Response to Referee #4:

The authors greatly appreciate the helpful comments of referee #4. In the following, we present our point-by-point responses to the Referee #4. The referees' comments are in blue italic and our responses are in black. We have made appropriate changes in the revised manuscript by taking the comments into account.

Figure 1. Simulations of CR * 100 (%) for SZA 30° with AOD from 0 to 2, at 380 nm, 500 nm, 675 nm and 870 nm, for 2020 annual average MERRA2 aerosols data in Beijing area for FOV between 1.2° and 5° .

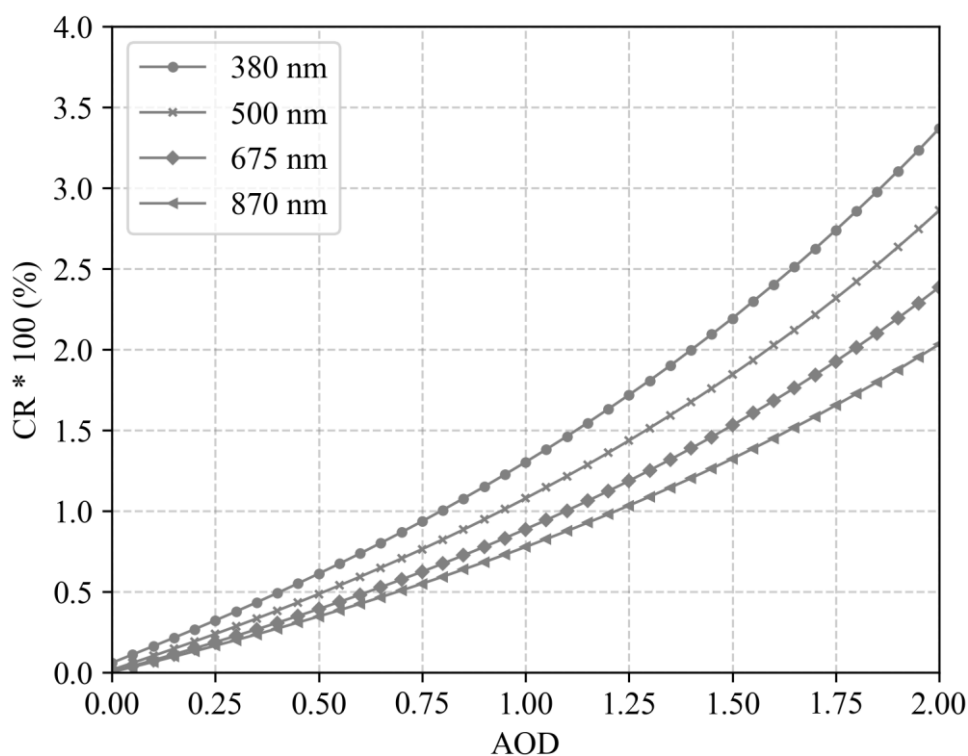
1. I find the quality of this work to be questionable, as will be revealed by several comments below. With this in mind, I don't really have a compelling reason to see this paper published. Had the authors succeeded in demonstrating the utility of the 1370 nm band with real data, I would be in favour of publication, but, as is, it could be that the lack of success is simply due to weaknesses in their method (see specific weaknesses below and also the neglect of forward scattering).

Thank you for pointing out the problem of the forward scattering issue due to the large FOV of the EKO instruments (5°), we did neglect the possible impact in previous algorithm. As shown in Fig. 1, the Circumsolar radiation Ratio (CR) at infrared wavelengths (870 nm) is very small, which will not affect the water vapor retrieval. However, in the inversion of aerosol optical depth, especially for high AOD loading atmosphere and at shorter wavelengths, it is sure necessary to perform CSR correction. We have added CSR correction in the revised manuscript.

Figure. 2 Water vapor transmittances calculated by MODTRAN4.3 and MODTRAN5.2 under the same conditions, respectively (SZA=0°, PWV=1.0 g*m⁻², FWHM=7 nm).

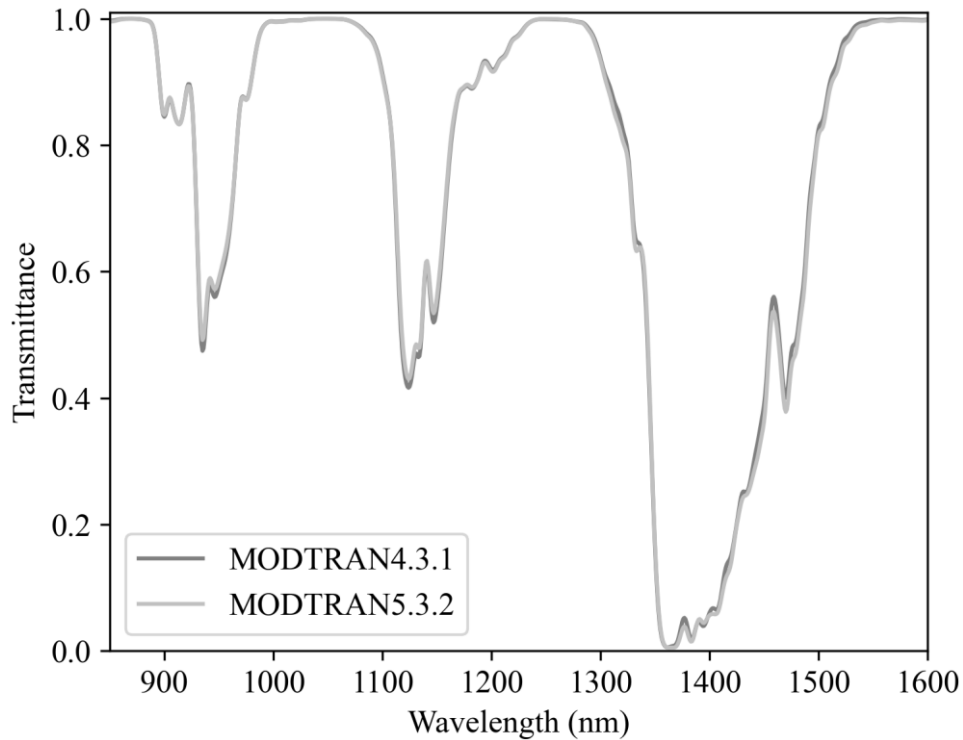
2. I agree with many of the comments raised previously by Reviewer 1 and find that Reviewer 2 was not thorough. Specifically, the point raised by Reviewer 1 about MS711 and MS712 being very different instruments is noteworthy. These instruments should be validated separately. Also, MODTRAN4.3 is used, which relies on HITRAN1996 (I believe). This is outdated. MODTRAN 5 and 6 are available and the

spectroscopic parameters for water vapor have changed. I know that the Brown et al., 2002 parameters are used in MODTRAN 5.2 for example:

Responses: Thank you for your comment. We have accepted the suggestions and comments proposed by reviewer 1. MS711 and MS712 have the same full width at half maximum (FWHM) and wavelength accuracy, and the possible impact of the differences between the two instruments has not been considered in the relevant applications of this manuscript. We noticed that the current version of MODTRAN4.3 may be old, so the water vapor transmittances were calculated under the same conditions using MODTRAN5.2 and MODTRAN4.3. Figure 2 shows the results of water vapor transmittances calculated using two versions of MODTRAN model. Because a narrow band other than single wavelength is used, the water vapor transmittances calculated by MODTRAN4.3 and MODTRAN5.2 are almost the same.
